S.S. "MONTROSE" NO. 529

SPECIFICATION OF WORK INVOLVED IN ALTERATION TO NOS. 5 and 6 HATCHES
AS CARRIED OUT ON S.S. "MONTCLARE" NO. 465

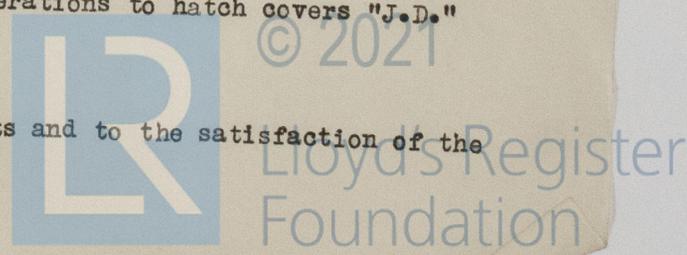
The hatch plugs and covers at present fitted in No.5 Hatchway to be retained the hatch beams being shifted from Frame 46 $\frac{1}{2}$ forward to about 48 Frame and placed in position to suit these plugs and covers. New plugs fitted aft of 48 Frame and hatch covers in No.6 Hatch altered as required.
